Project	IEEE 802.16 Broadband Wireless Access Working Group < http://ieee802.org/16 >	
Title	amendment for MBS primitive	
Date Submitted	2006-11-16	
Source(s)	ZTE corporation	xu.ling@zte.com.cn jqian@zte.usa.com chuang@zte.usa.com
Re:	Contribution on comments to P802.16g-D5	
Abstract	In this contribution, we propose to add MBS Info attribution within MBS primitive and some clarification about MBS related attribute.	
Purpose	Adoption	
Notice	This document has been prepared to assist IEEE 802.16. It is offered as a basis for discussion and is not binding on the contributing individual(s) or organization(s). The material in this document is subject to change in form and content after further study. The contributor(s) reserve(s) the right to add, amend or withdraw material contained herein.	
Release	The contributor grants a free, irrevocable license to the IEEE to incorporate text contained in this contribution, and any modifications thereof, in the creation of an IEEE Standards publication; to copyright in the IEEE's name any IEEE Standards publication even though it may include portions of this contribution; and at the IEEE's sole discretion to permit others to reproduce in whole or

Figure 517— MBS Configuration management Primitives (Create and Delete)

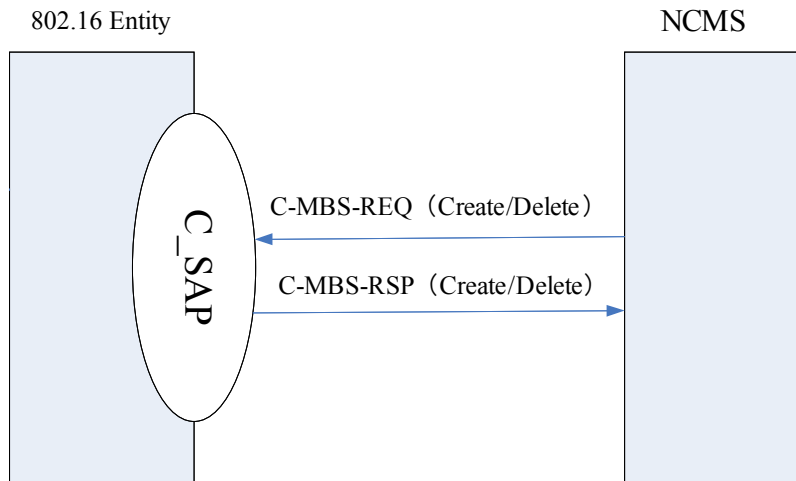
In the current baseline document, it has a MBS section. In this section, there has defined how to set MBS information to a BS, but if the information has been changed, it does not specify clearly how BS will do. To resolve the issue, this contribution adds some clarifications about this issue. It also adds new MBS primitives to give the information of MBS attribute which will initiate the air link to be created or deleted.

14.2.12.3 MBS Configuration management

14.2.12.3.2.1 C-MBS-REQ (Create)

This primitive can be from NCMS, and is used to notify the BSs which are in one MBS zone to create a new MBS transmitted radio link

When Operation Type is set to 'Delete', this primitive shall be used to initiate an existing MBS radio link deletion by NCMS.
